79 Port Road, Thebarton

211/M022/17

OVERVIEW

ASSESSMENT REPORT

Figure 8 - Traffic Control Strategies adjacent the Loading Dock

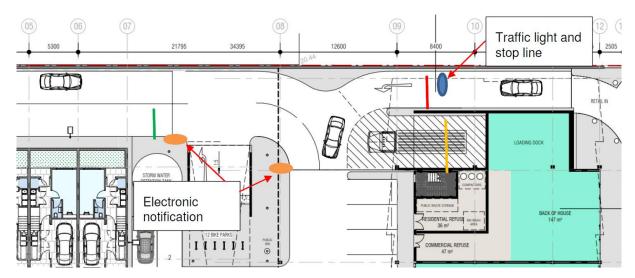
- relocation of the proposed loading dock away from the Port Road access and internal road junction is recommended to minimise potential for conflicting vehicle movements and compromised sightlines for heavy vehicle operators in this location;

- potential for vehicle conflict at the loading bay access point exacerbated by lack of traffic control systems;
- siting of the townhouses should be modified to provide a minimum 1m setback from the western property boundary to enable future widening of Walsh Street to accommodate anticipated traffic impacts.

- sight distances for road users adjacent the car park ramp will be maintained via an open portion of barrier against the east lane;
- a give way holding line at the base of the ramp will assign right of way to east and west-bound traffic;
- a service vehicle detection system utilising laser technology within the loading dock and internal roadway will:
 - identify entry of an MRV through the Port Road slip lane (red line below);
 - trigger red (stop) lights to hold other vehicles until the MRV enters the loading bay via a reversing manoeuvre or passes through to Walsh Street;
 - identify when an MRV has entered the loading dock (orange line below) releasing the hold point and enabling traffic flow; and
 - identify when the loading dock is already occupied by an MRV, instructing a second oncoming MRV to pass through to Walsh Street (signal would be visible at the green line below).

• the detection mechanism would be complemented by an electronic notification system providing warning of a manoeuvring or exiting MRV to motorists approaching the base of the car park ramp (from upper levels) and exiting the ground floor car park.

The notification system would only operate when the MRV detection mechanism is active. In combination with the restricted (off peak) times which service deliveries would be programmed to occur, the detection and notification systems are expected provide sufficient means of managing traffic and minimising risks of vehicle conflict in this location.
